LiDAR QAQC Report
Hawaii TO12: Molokai, Maui, Lanai islands
March 2008

Prepared by:
 **Dewberry**
Fairfax, VA

EXECUTIVE SUMMARY

Figure 7 – Minimum elevation in ground LAS files (in feet)

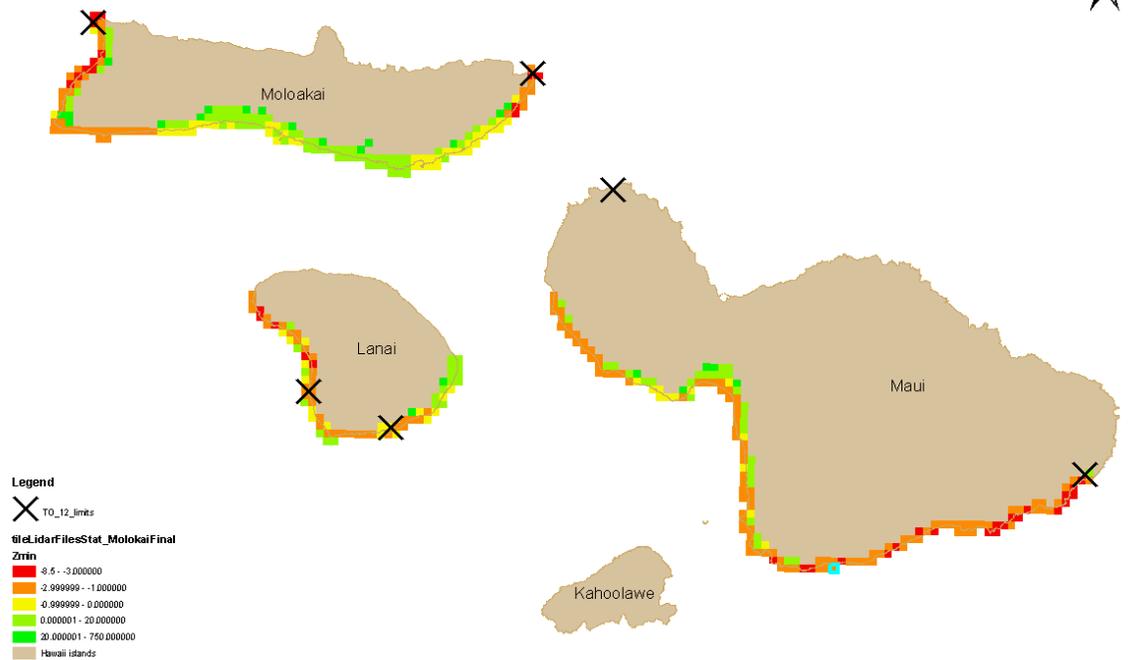
We checked the minimum and maximum elevation values in each ground classified files. Figure 7 illustrates the Zmin value for each tile; it can be noticed that a lot of the files situated on the east part of Maui have negative Zmin values, and 30 files have a Zmin value under -5ft, further investigation may be needed to explain this. Nevertheless, we can see on Figure 8 that there is no noticeable anomaly for the max value. The 3 tiles in Lanai Island that have values above 600ft are very steep cliffs right on the coast as seen in Figure 9. Consequently, all highest Zmax values are legitimate LiDAR points. We can also see that the project boundary is very close to the shoreline on this particular area.

Figure 10 – Histogram of the elevation differences between LiDAR and Checkpoints

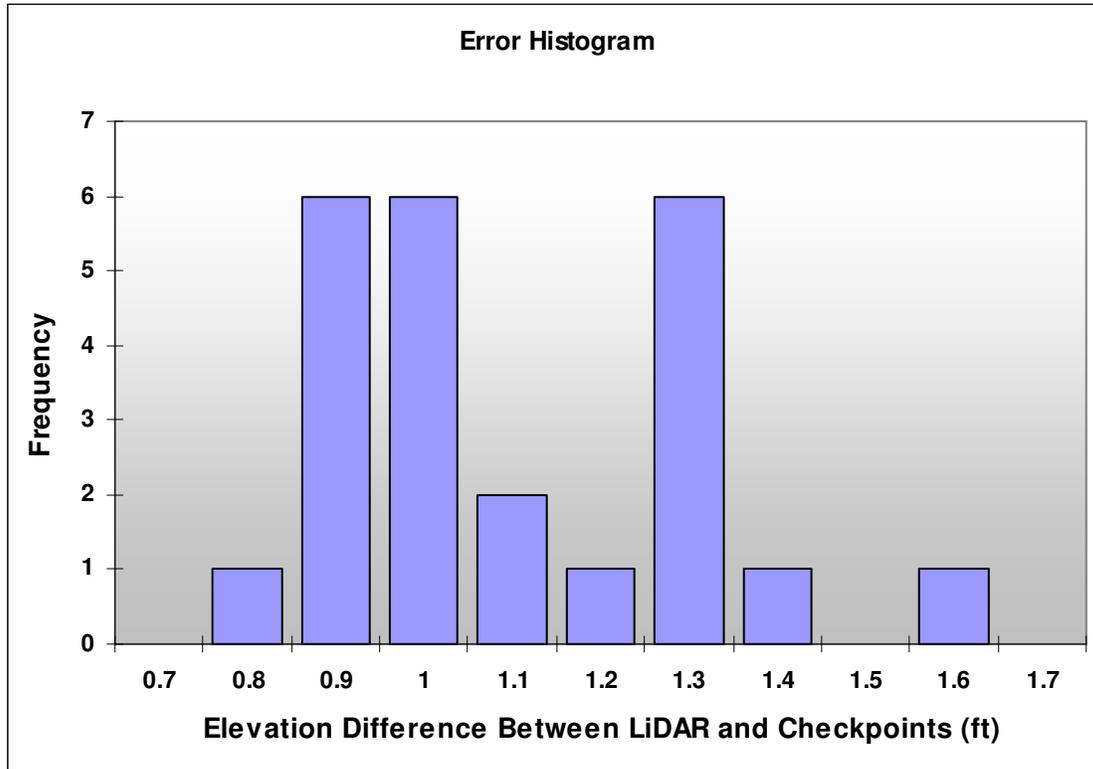
The initial data was tested and the RMSE value was slightly over 1ft and did not meet the NSSDA standard. There were no actual outliers as the errors are regularly distributed between 0.79 and 1.51ft, but 2 errors were larger than the 95th percentile (1.37ft), which itself was larger than the specification (1.19ft).

By reviewing the distribution of the errors in Figure 10, it was apparent that there was a systematic positive bias in the data. Based on what we know of the islands and the lack of an official vertical datum, it was conceivable that Airborne 1 used different vertical values for their control and the processing of the LiDAR data. Due to our knowledge of vertical control issues on this island we suggested that the data be reexamined by Airborne1 to investigate the cause of this discrepancy.

After review by Airborne 1 the data was vertically adjusted based on utilizing the same control as the checkpoints and resubmitted to us. The survey report by McGee Surveying clearly outlines how the vertical control was derived for the checkpoints and why these values take precedent over other local vertical datums for this area (see Appendix B. By utilizing the same control values and recomputing the RMSE, the Airborne 1 data meets the specifications as shown in Table 1.

Figure 13 – Elevation errors (sorted)

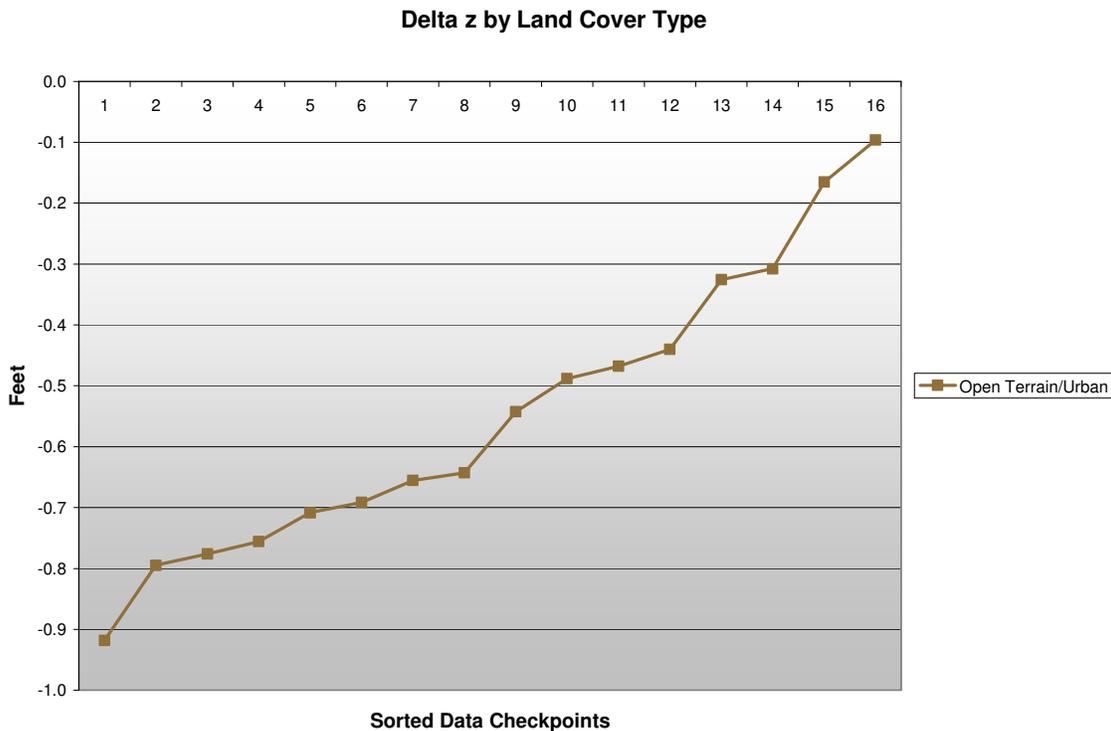
The consolidated RMSE meets the NSSDA standard. We noticed that all the errors are negative as seen in Figure 13 indicating that a bias exists in the data.

Figure 14 – 3D models of ground LiDAR data from NOAA (left from the yellow dashed line) and Airborne 1. The cross section has been drawn where the 2 datasets are overlapping. (Tile Number 000179)

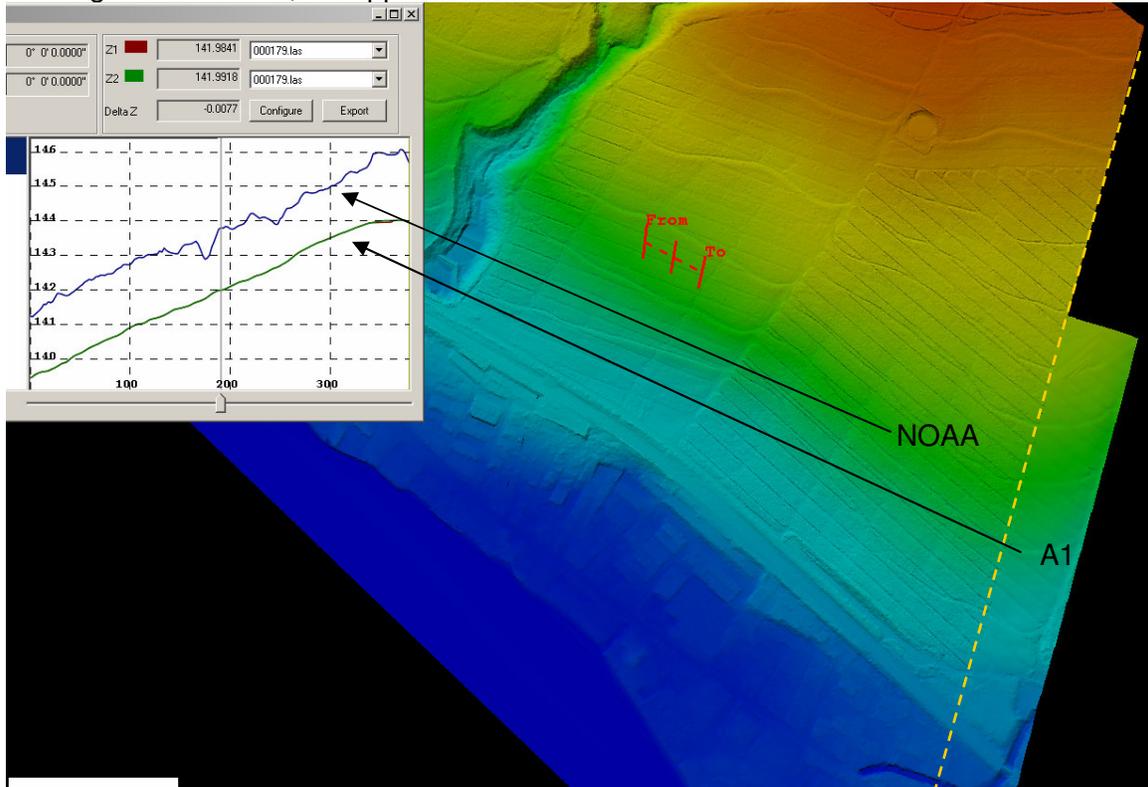
We checked the elevation matching between the two sources and found about 1 feet discrepancy between NOAA and A-1 data (NOAA data is generally above the A-1 data as shown in Figure 14). When computing the RMSE over a mixed dataset, we noticed that, except for one point, the NOAA data fit our survey points (see check point error

graph in Figure 15) confirming that the Maui data might have a bias. However, in order to merge the datasets, we applied a -1ft correction to the NOAA data.

Figure 20 – Extracted feature model (up) and bare earth model (down). Well defined stream channel and possible vegetation remains on the slopes. (Tile 0441)

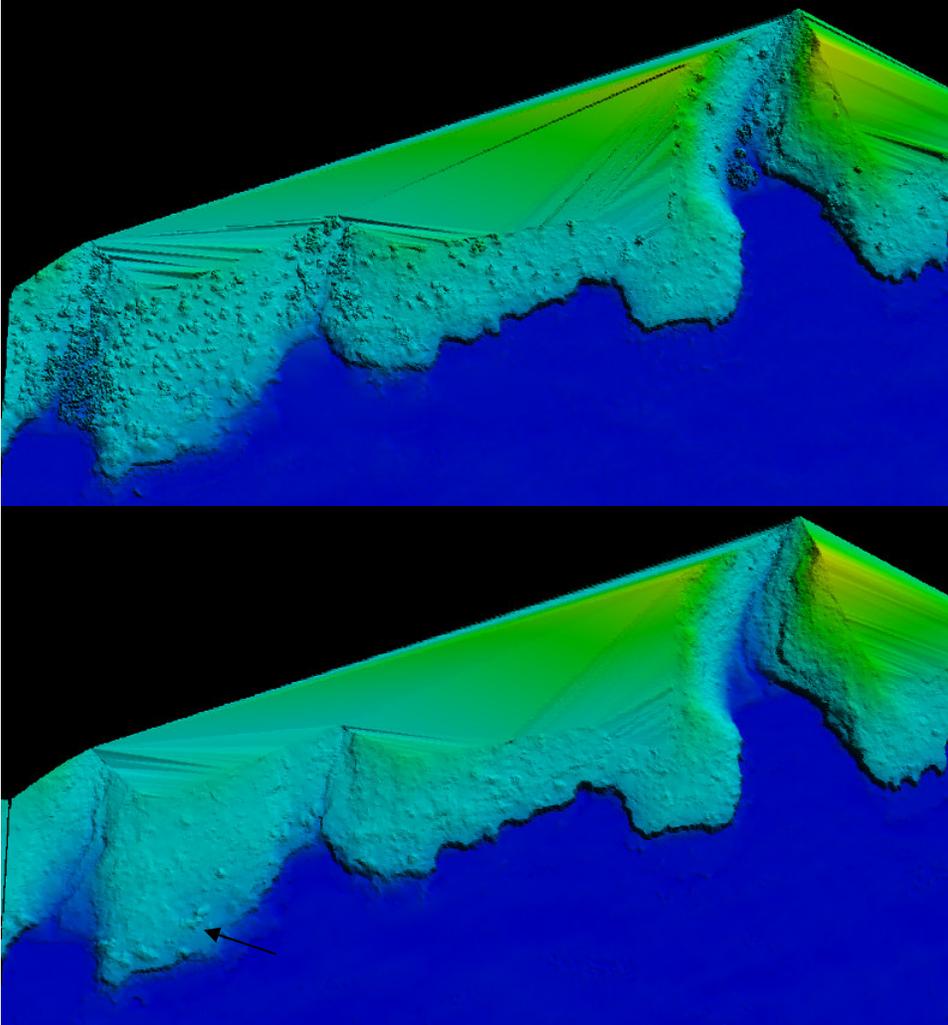
The east part of the project area (south facing shoreline) exhibits a slightly smoother topography. On this area, well defined stream channels were noticed. The only types of issues we faced were possible remains of vegetation and one instance of poor LiDAR penetration in highly vegetated area (this issue is documented in the next section).

Figure 23 – Poor LiDAR penetration in dense vegetation. (Tile 1045)

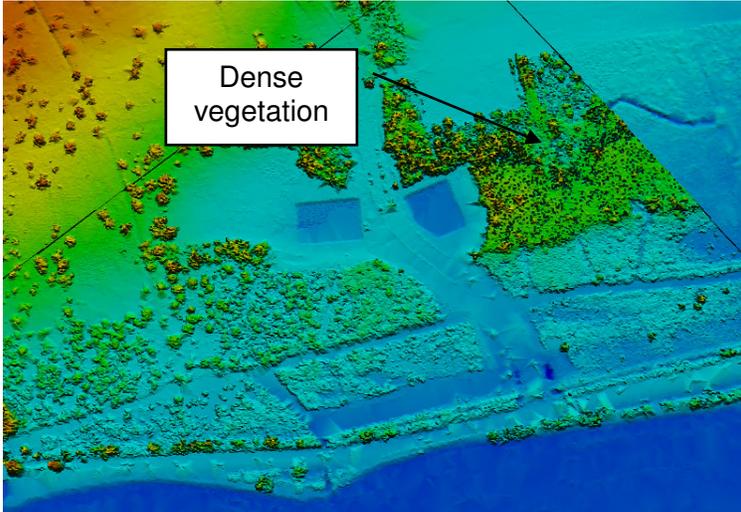
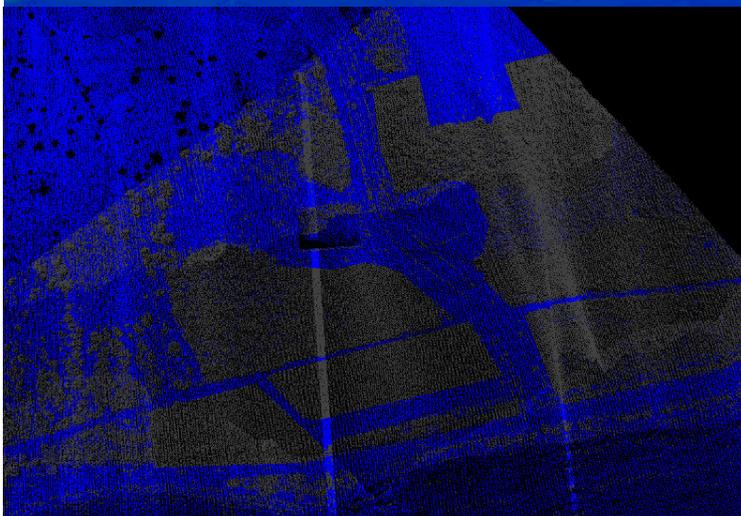
Nevertheless, we have also often encountered more problematic tiles during our review of Maui. First, we have faced a recurring (over all three islands) issue of dramatic low density of points in really densely vegetated areas (see Figure 23 and Figure 26, upper right corner). It is believed that this may be caused by a poor penetration of the LiDAR beam between the leaves and branches because of their density.

Figure 26 – Point density on bare earth model. Red indicates low density areas. Black holes in corners of adjacent tiles are caused by the absence of ground points at this location. (Tile 1059)

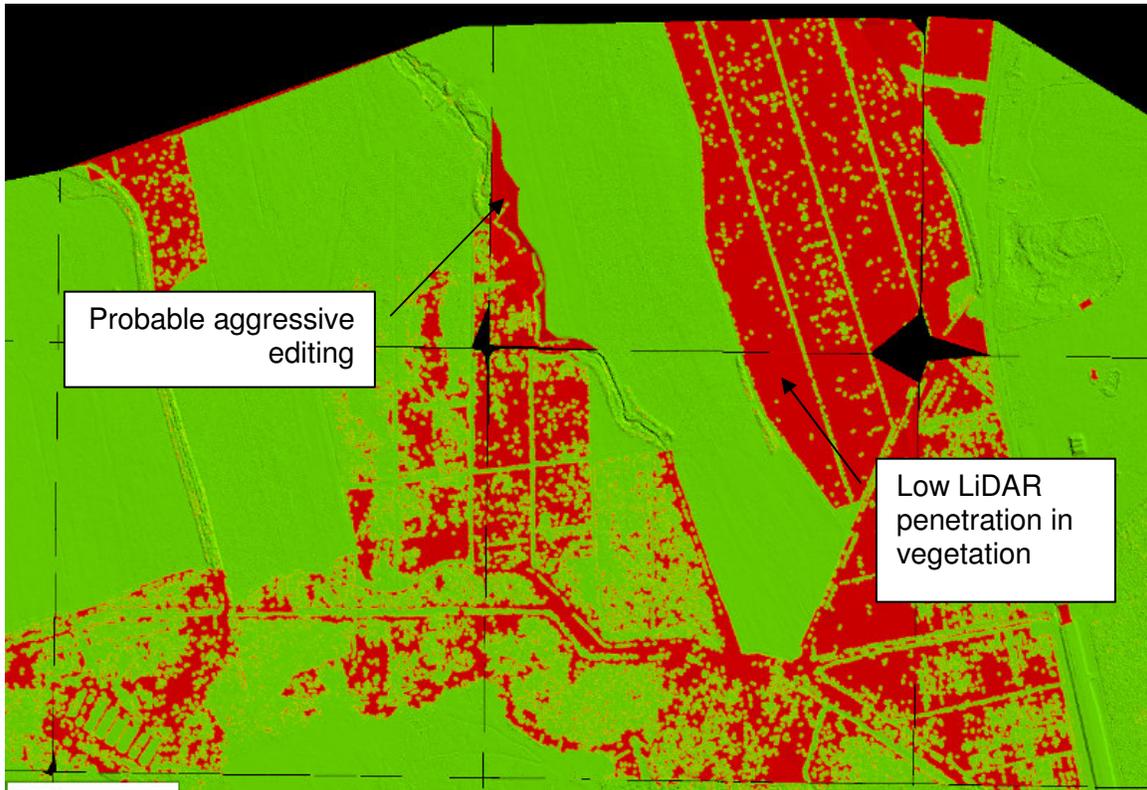
In addition, the Maalaea Bay Area especially catches our attention as significant classification issues were found there. Its location is given in Figure 25. In this case, instances of low density of ground points seem to be caused by an overaggressive classification of vegetation. Indeed, processing discrepancies were noticeable between two adjacent tiles as illustrated Figure 27 and Figure 28. Moreover, a few divots were found along roads (Figure 29).

Figure 30 – Gap in data (point density of ground model, red indicates no data), the small rectangular red shapes are legitimate removed building footprint (Maui, Tile 1398)

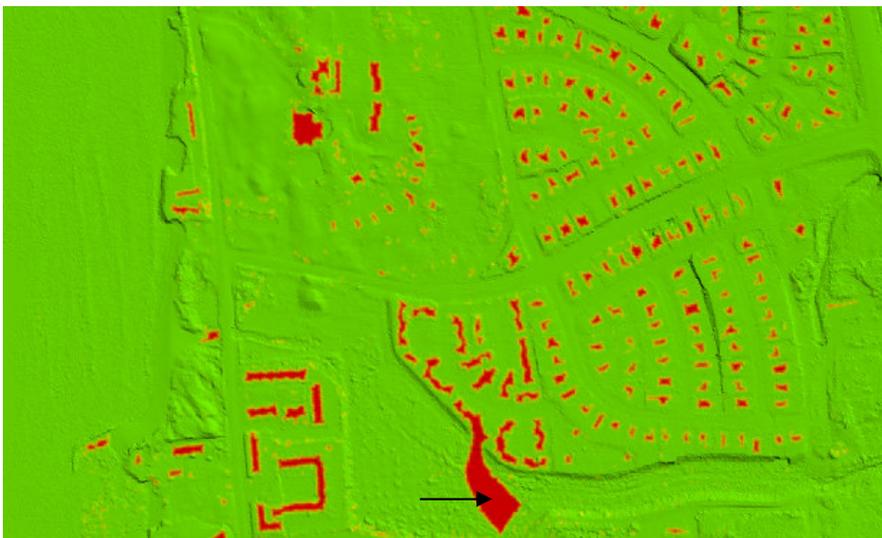
Finally, Airborne 1 stated to us in a letter that there were multiple data gaps found in the Maui tiles. On average, these gaps have an area of 1 acre or less (see example Figure 30).

Figure 32 – Hole in data - Ground point density (Tile 002)

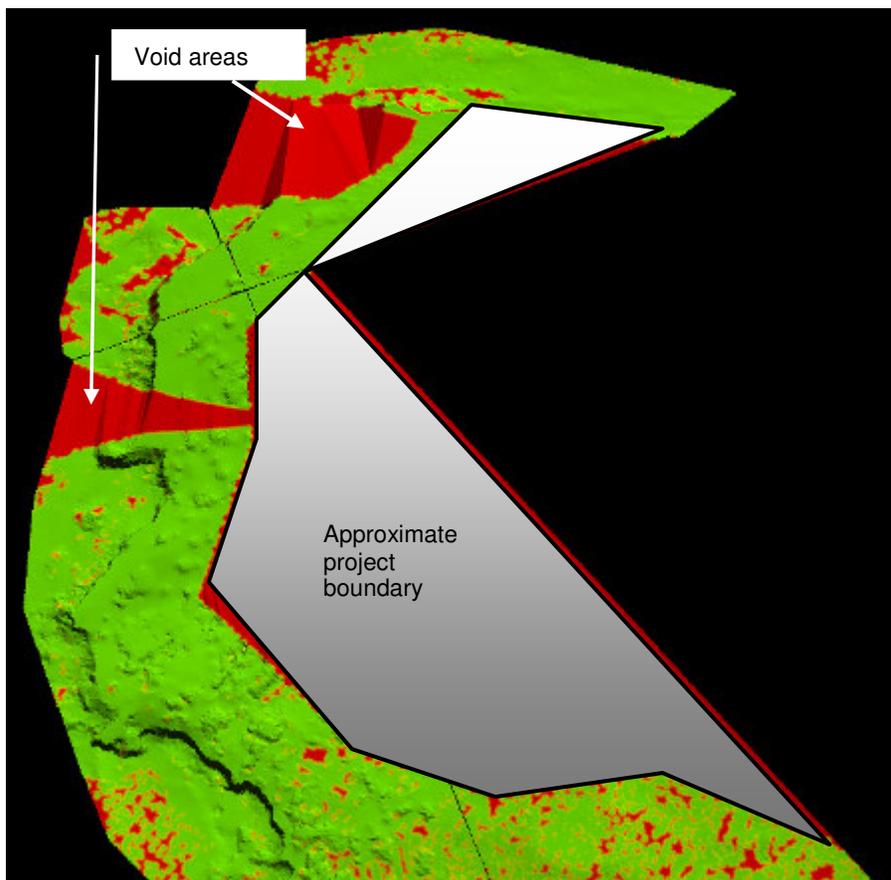
In addition, instances of holes in the data were found, especially in the upper west side of the project area as illustrated in Figure 32 and Figure 33. Another specific issue for this island was a cornrow effect visible in several adjacent tiles (Figure 34). There are multiple reasons as to why this happens but the end result is that adjacent scan lines are slightly offset from each other. This will give the effect that there are alternating rows of higher and then lower elevations. Although this is common with LiDAR data, as long as the elevation differences are less than 20 cm and the occurrences are minimized, it is acceptable because it is within the noise and accuracy levels. However this also can be an indication that the sensor is mis-calibrated, or offsets exist between adjacent flight lines so each area identified is analyzed.
